ENGINEERING CHANGE NOTICE

1. ECN 186756

| 5. Project Title/No./Work Order No. 300-FF-5 RI/FS | | | | 6. Bldg./Sys./Fac. No. | | 7. Impact Level 4 | |
| 12. Description of Change Attached is a complete copy of all 300-FF-5 Work Plan changes as of September 24, 1992. Included in this ECN are Change Control Forms 300-FF-5-01, 300-FF-5-02, 300-FF-5-04, 300-FF-5-05, 300-FF-5-06, 300-FF-5-07, 300-FF-5-08, 300-FF-5-10, 300-FF-5-11, 300-FF-5-12, 300-FF-5-13, 300-FF-5-14, 300-FF-5-15, 300-FF-5-17, 300-FF-5-19, 300-FF-5-20, and 300-FF-5-21. Also included is a change control log which identifies where discussions of the individual change forms can be found. Future work plan changes will be made on individual ECN's. | | | | | | | |

Well 399-4-7:

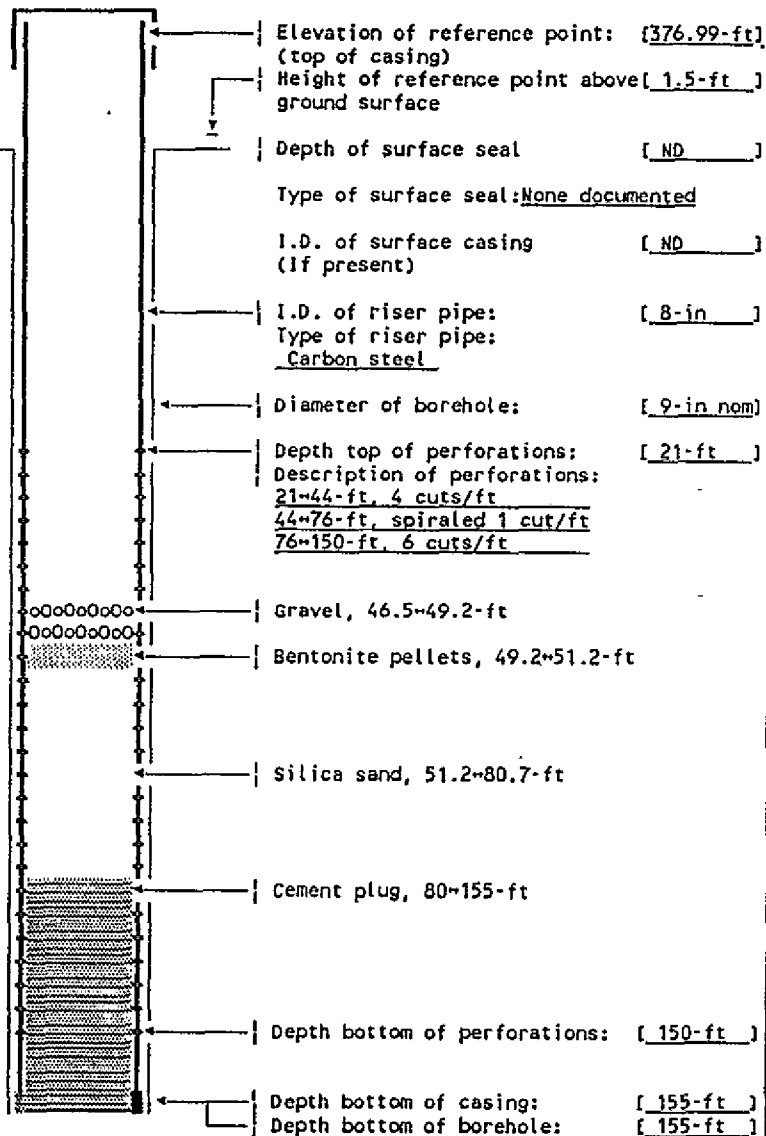
Well perforations extend from 21 to 150 ft. The interval was shortened in June of 1987 by placing a wooden and cement plug from 155 to 80 ft. In July of 1991, the interval was shortened again from 80.7 to 51.2 ft using silica sand. Bentonite pellets were added from 51.2 to 49.2 ft and gravel was placed from 49.2 to 46.5 ft.

A surface seal will be installed in early 1992 by overdrilling the casing with an auger to 18 ft. Bentonite will be added from 18 to 16 ft and cement grout then pumped to the surface. This will result in a 16 to 17 ft surface seal.

This represents no major impact on the integrity of samples to be taken from these wells. Rather it is a justifiable modification of the guidance provided in WAC 173-160-550 due to conditions encountered in the field. It is being noted as a Change Form to document regulatory concurrence with the actions taken or planned.

Figure 43. River Sampling Layout Associated with Riverbank Spring Locations.

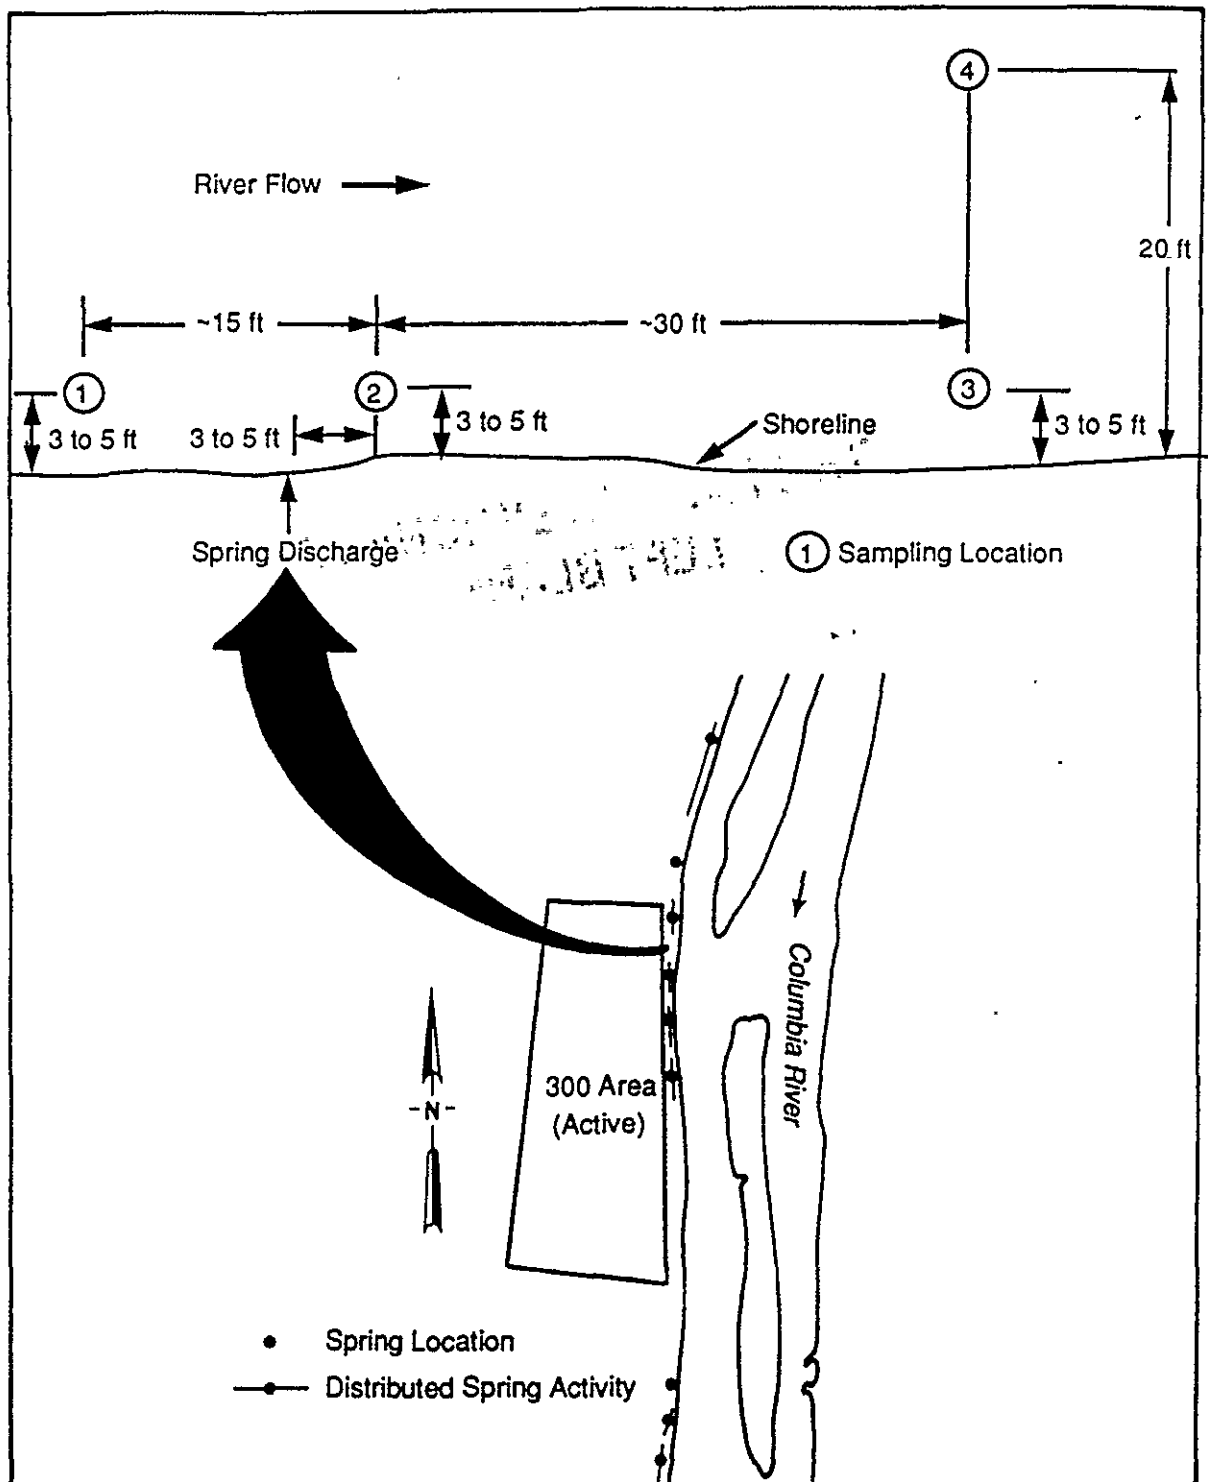
| <p>Description of Change</p> <p>In Task 5C, Near Shore River Water and Sediment, described in Section 5.3.5.3 of the work plan a sampling scheme is described. This is shown as Figure 43 in the work plan. As a result of a meeting held on September 17, 1992 with the regulators it was agreed that sampling of the river would be modified. Figure 1 from the FSP (WHC-SD-EN-AP-107) for this activity is also attached and identifies the 4 major spring locations that were sampled in conjunction with the river sampling. Upriver from spring site 6 a transect sampling at about 3 ft, 10 ft, and 20 ft from shoreline would be performed. Samples would be taken at mid river depth from each location. Immediately below spring site 9 a similar transect sampling would be performed. Downstream from spring site 11 a third and final transect sampling would be performed. Instead of 4 samples at all spring locations only 3 samples at 3 locations would be taken.</p> <p>Note: Include affected page number Section 5.3.5.3 (WP-181-184), Figure 43 (WP-182), Section 2.2 (SAP/FSP-23), Table 6 (SAP/FSP-24), Figure 5 (SAP/FSP-26)</p> | | |

| <p>Justification and Impact of Change</p> <p>Spring Sites 6, 7, 9, and 11 are representative of the springs that discharge into the river at the 300 Area. Transect sampling at sites 6 and 11 represent upstream and downstream conditions while site 9 represents discharge from a spring. Transect sampling at 3, 10, and 20 ft from shoreline relates to dispersion of the springs in the river. Sufficient data will be obtained by this method of sampling from which impacts to the river from the springs may be assessed.</p> | | |
